**UNITED STATES  
NUCLEAR REGULATORY COMMISSION  
ADVISORY COMMITTEE ON REACTOR SAFEGUARDS  
WASHINGTON, DC 20555 - 0001**

SUBJECT:                   CERTIFIED MINUTES OF THE ACRS ADVANCED BOILING  
                                  WATER REACTOR SUBCOMMITTEE MEETING ON APRIL 24,  
                                  2013

ADVISORY COMMITTEE ON REACTOR SAFEGUARDS  
MINUTES OF THE ACRS ABWR SUBCOMMITTEE MEETING ON APRIL 24, 2013

# Hydrology Non-concurrence Issues

**FSAR Figure 2.4S.4-13c:**  
Comparison of BREACH and FLDWAV Outflow Hydrographs

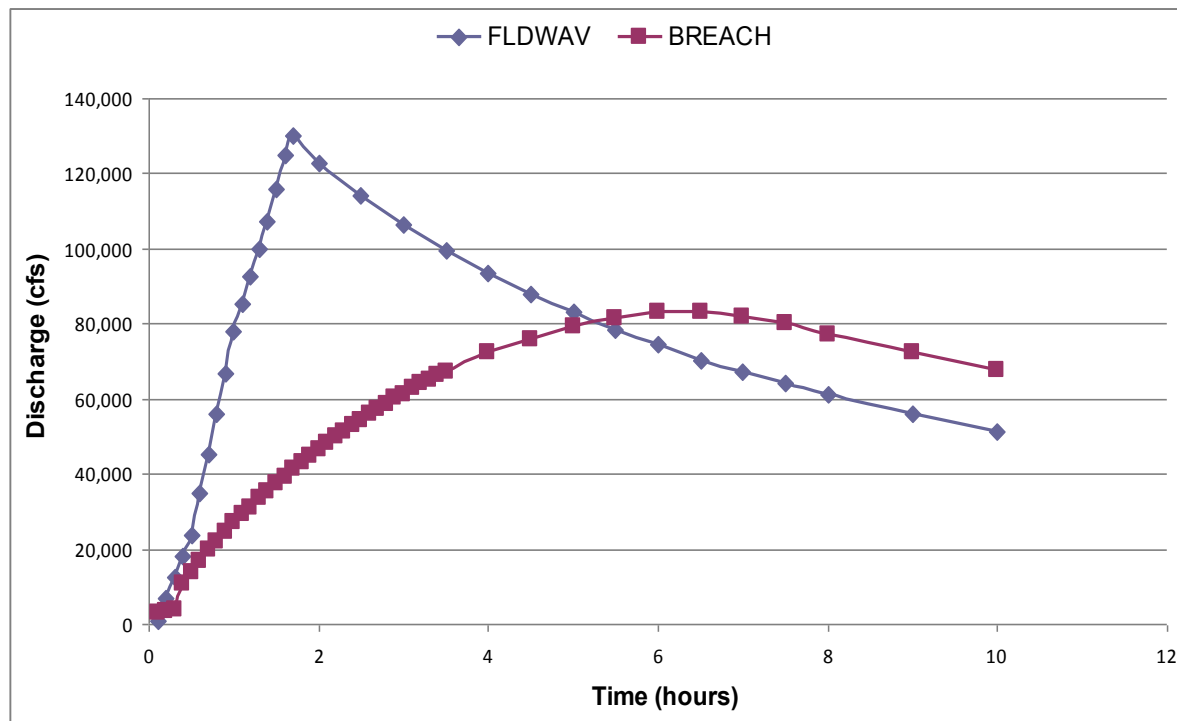
**How does MCR breach width derived from Froehlich's equation used in the FLDWAV model compare with value used in confirmatory BREACH Model?**

PEAK FLOW			Final
	Flow	Time	Width	Width
	(cfs)	(Hours)	(feet)	(feet)
FLDWAV-STP COLA Model	130,000	1.7	417	417
BREACH-STP	83,000	6.25	398	485
Froehlich Equations	62,600	10.6		417

12                   But we've added another aspect of the  
13 Froehlich equations. If you put information into  
14 FLDWAV regarding the breach growth rate and time and  
15 width, you'll get the green curve. And so what this  
16 shows, we think, is some idea of the conservatism that  
17 we have in our analysis right now.

## Breach & Tailwater Condition

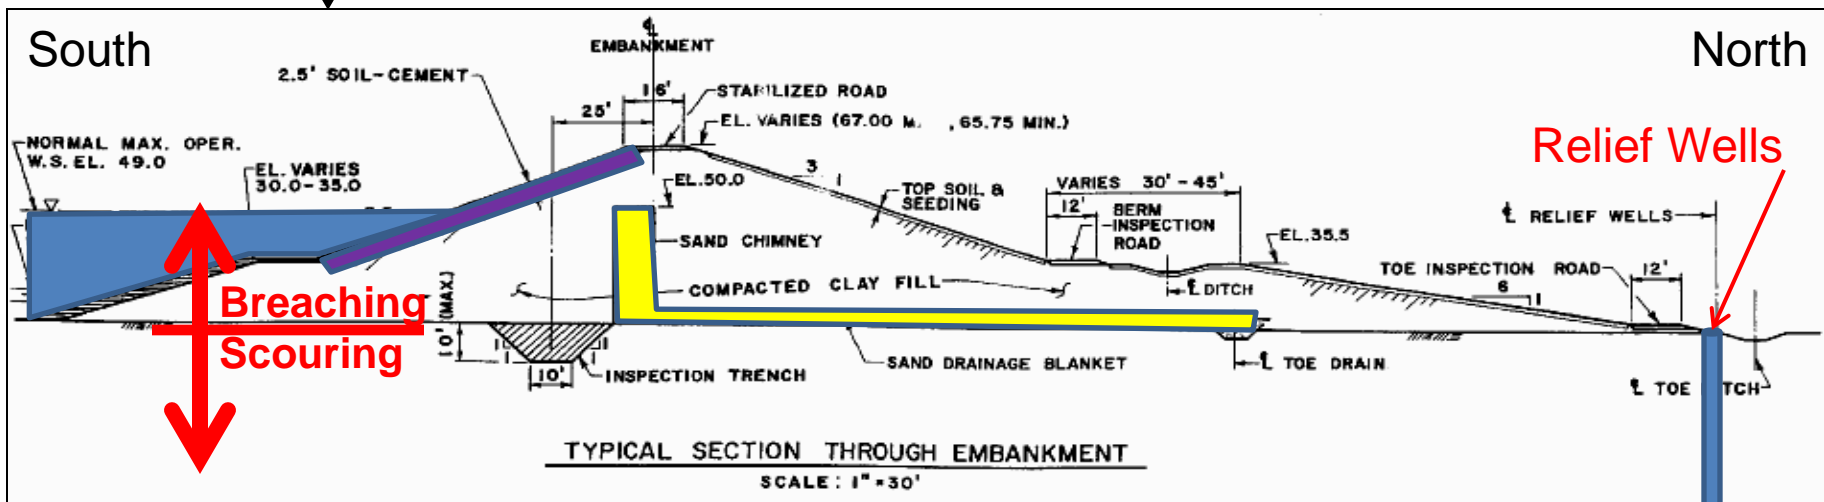
- North levee: 4200 ft
- Elevation: 29~32 ft msl (**upslope**)
- Breach bottom roughness will be increased by broken cement blocks.

# Dam/Levee Breach Flood Analysis

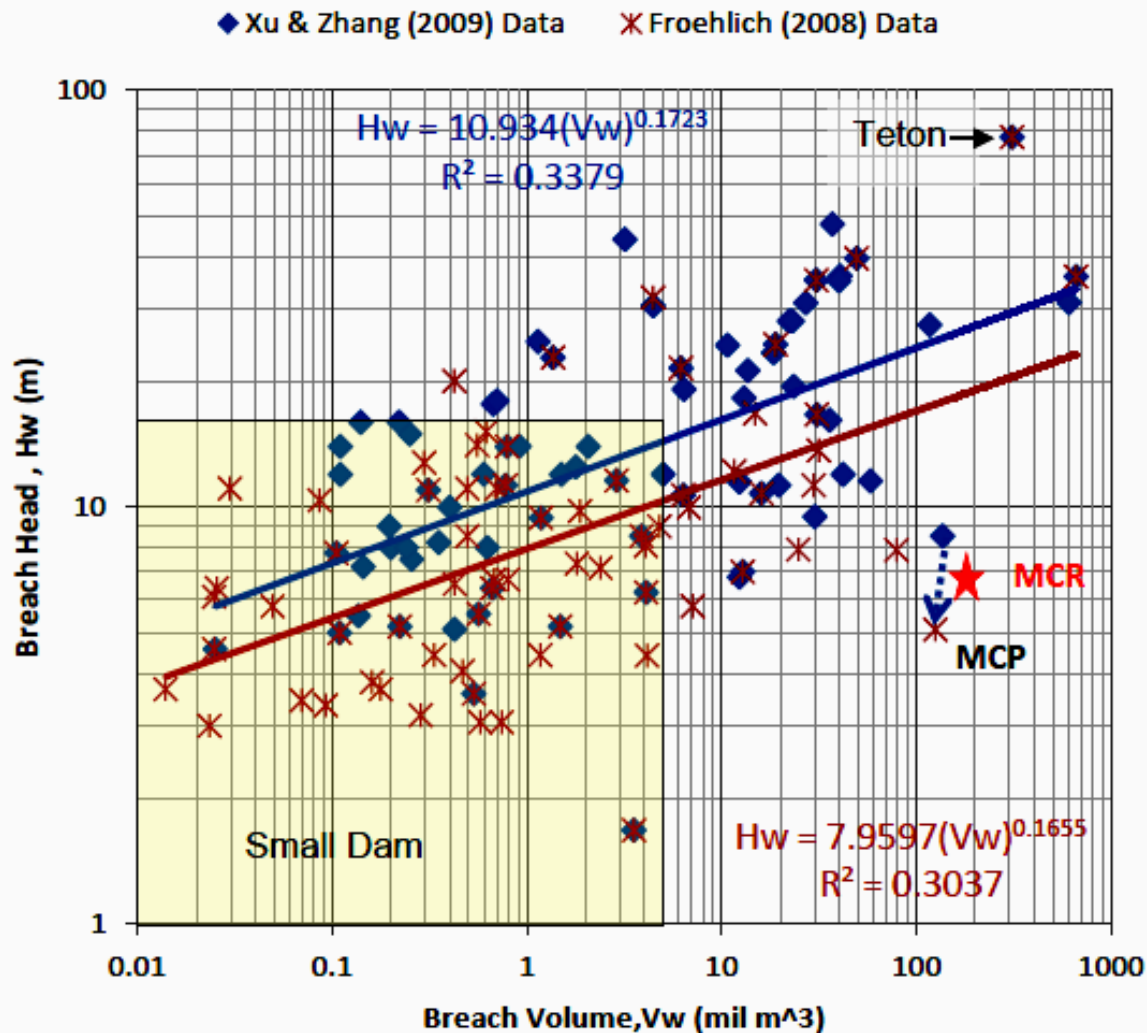
## ➤ My Re-analysis:

MLM breach width: 745~1738 ft  
Peak flow: 251 kcfs by 10 equations  
269 kcfs by BREACH  
280 kcfs by FLDWAV

- STP's breach width estimate is not conservative compared to other similar cases:
  - ✓ 2000 ft for STP Units 1&2
  - ✓ 2034 ft for Victoria ESP
  - ✓ 4757 ft for STP FSAR v. 0&1
  - ✓ 600 ft on the Martin Cooling Pond breach.
- Other government guides (USBR, USACE, etc.) recommend to '**use all equations, then make an engineering judgment.**' However, STP did not use the MLM breach width equation as well as many breach peak flow equations, resulting in non-conservative parameter estimates (see my re-analysis).

### **Issues:**

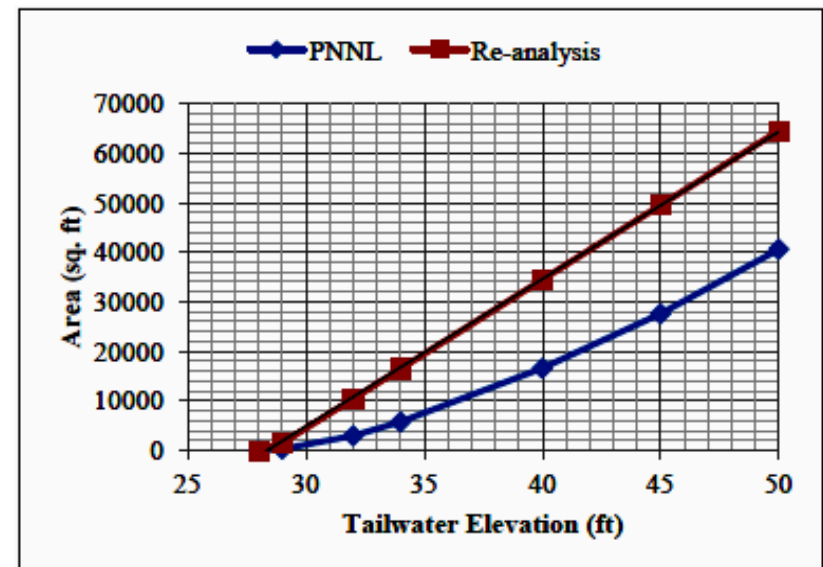
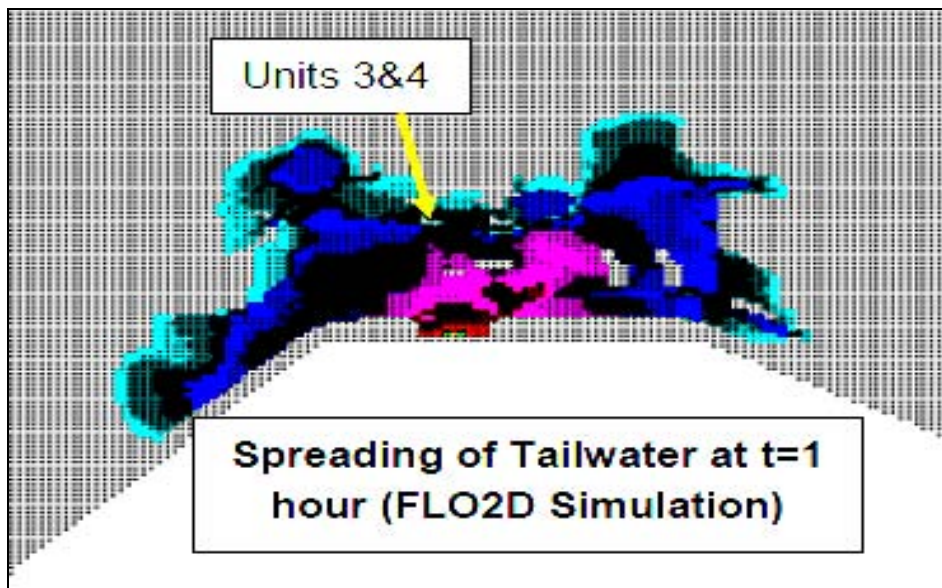
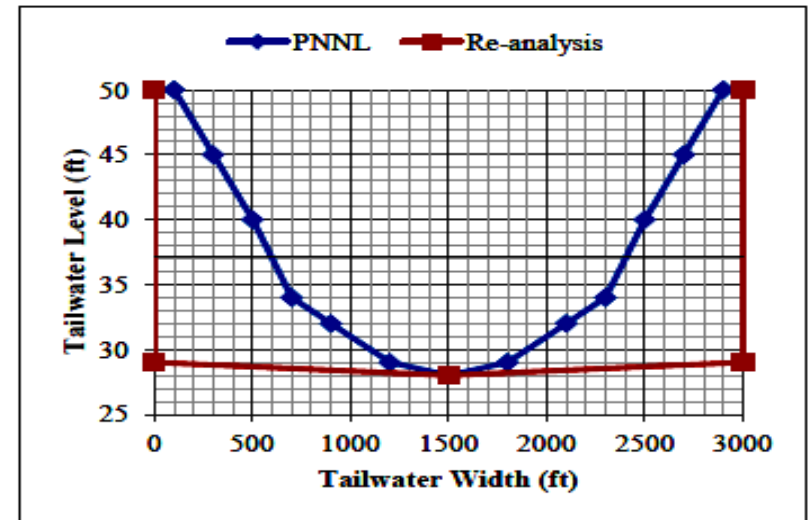
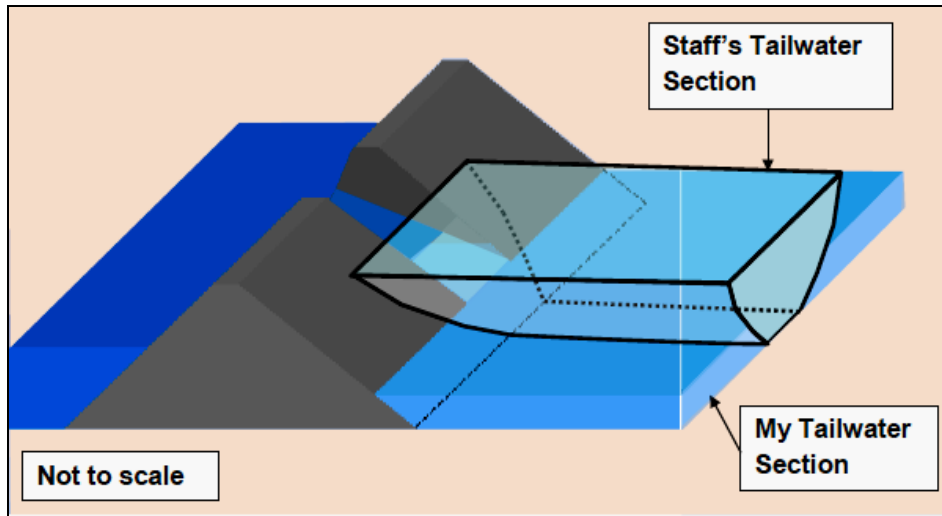
- The staff used an **unrealistically small** tailwater section (width of 600 ft) compared to the anticipated breach width (The same is true in FSAR Table 2.4.4-6b). Then the staff concluded that tailwater section is not critical in breach and that a small tailwater section is realistic.

- I disagree. The MCR breach tailwater zone is wide (>1 mile) overland plain with mild upslope to the North (4 ft to 1 mi), so that the tailwater spreads quickly and widely to the lateral directions - **A wide tailwater section is realistic.**
- My re-analysis shows that small tailwater section produces high tailwater level at the beginning of breach, resulting in reducing breach head and resulting breach width significantly. My sensitivity analysis also shows that tailwater section is very critical in breach.

# BREACH: Tailwater Section Width vs. Breach Width

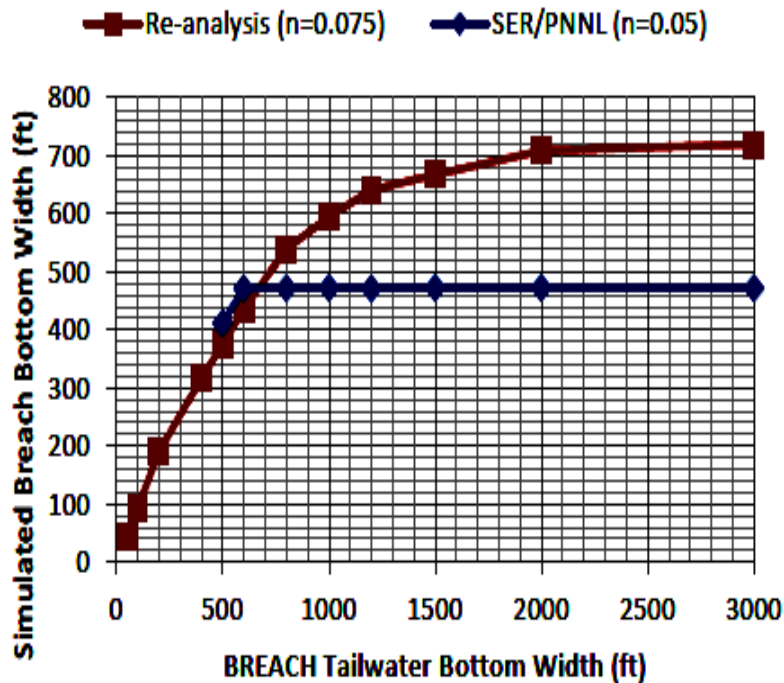
- The staff/PNNL selected  $n=0.075$ . However, they performed a tailwater section sensitivity analysis with  $n=0.05$ , then concluded that the tailwater section is not a limiting factor. (SER p. 51) – **This conclusion is incorrect as my re-analysis shows that tailwater section is very sensitive in breach.**
- The staff obtained peak flow of 130 kcfs using BREACH with  $n=0.075$  and a small tailwater section, then concluded that STP's breach estimate is acceptable – **The model is flawed.**
- In my re-analysis, I used a width of 3000 ft, but a tailwater width greater than 2000 ft is acceptable (see Ahn, 2012a).

# Sensitivity of Two Breach Parameters (n-value and Tailwater Section)

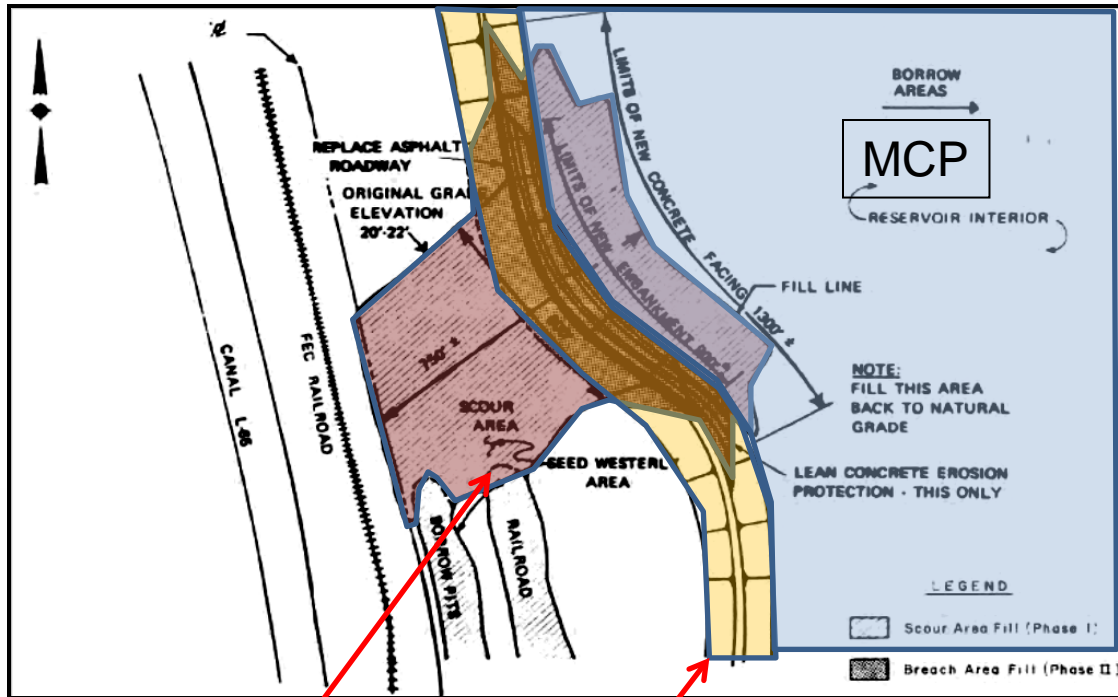
- The differences in outflows are due to width of the tailwater section and soil properties.

- It is clear from the figure that the staff underestimated breach outflows by using a small tailwater section.

# #3 Maximum Groundwater Level

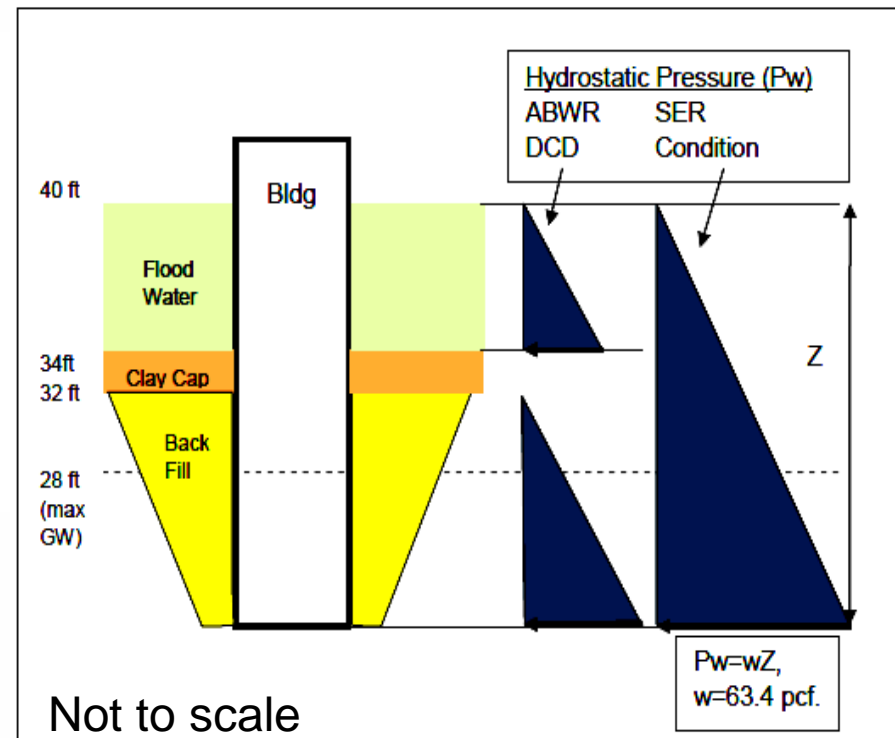
Issue: The departure of the maximum groundwater level (ABWR DCD Tier 1 Site Parameters) is not addressed in subsequent structural analyses.

## B1 My Comments on Dr. Patev's Review of MCR Breach

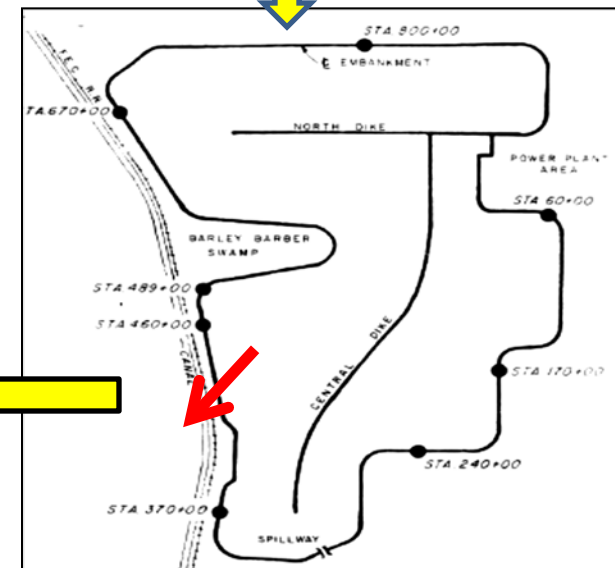
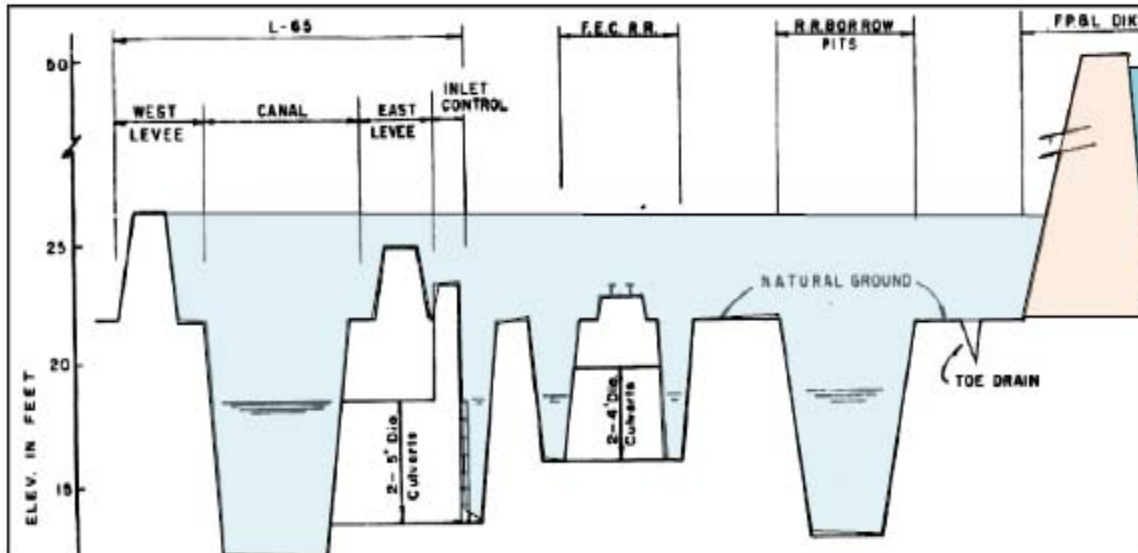
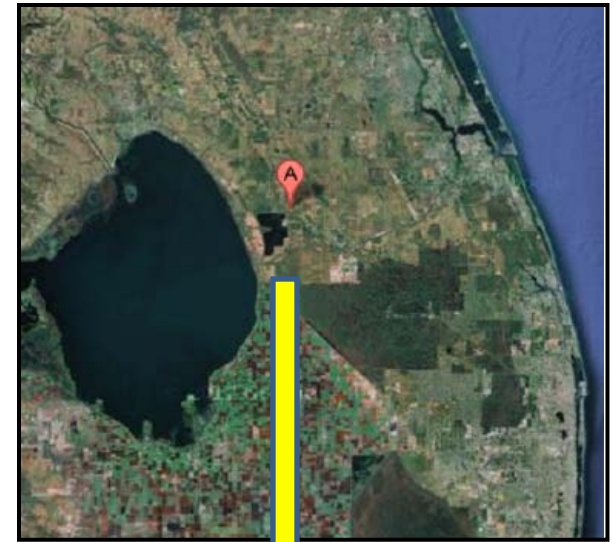
Dr. Patev focused his review on the geotechnical aspects of MCR breach, then concluded that a wide breach with scour hole is highly unlikely. However many of his assertions are speculative or not factual as:

- Seepage failure is highly unlikely because of compacted silt-clay, seepage control system (e.g., relief wells, sand chimney, berms, etc.), and low permeability ( $10^{-5}$  cm/sec). Foundation materials consist with two different clays. – **Comment: He failed to recognize sand layers in foundation, through which seepage has been observed.**
